Distributed Generation Technical Interconnection Requirements

Addendum

Distribution Voltage Performance Criteria and Requirements

September 2010

Scenario 1 - DG voltage control interferes with VR

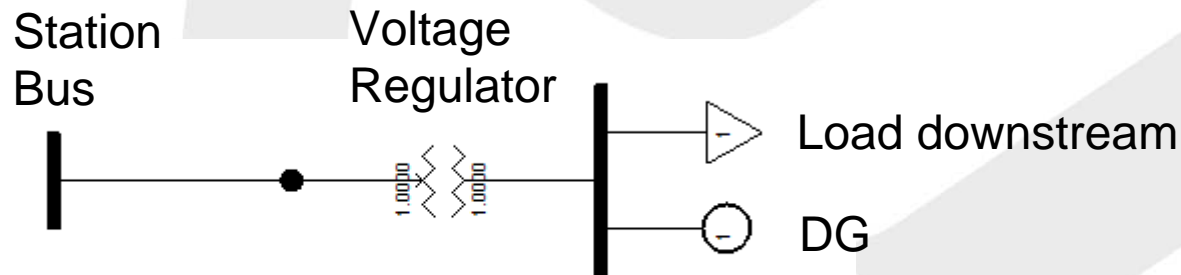
Load voltage controlled by the DG.

The voltage regulator does not respond to load correctly.

Load voltage uncontrolled immediately after the DG trips.

Scenario 2 – DG voltage control aggravates fluctuation

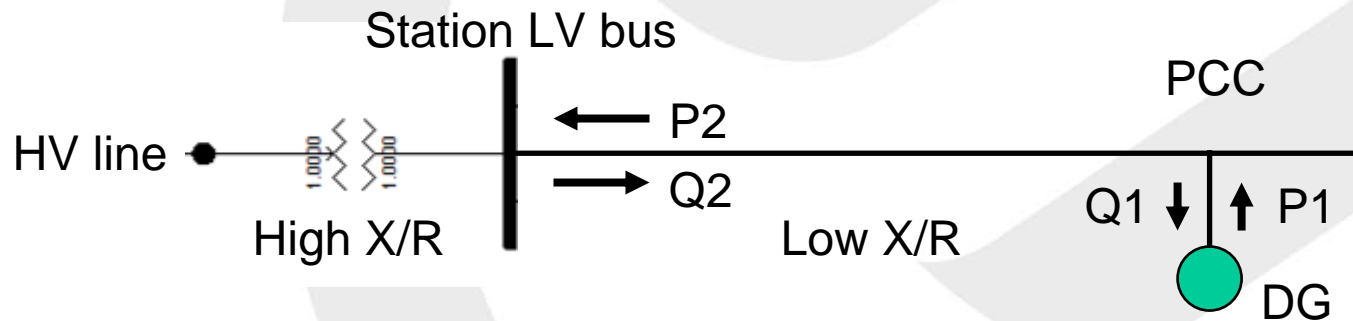
DG aggressively varies Q1 to control PCC voltage as P1 fluctuating.

As result, Q2 fluctuation at station LV bus is aggravated.

Station LV bus voltage is sensitive to Q2 fluctuation.
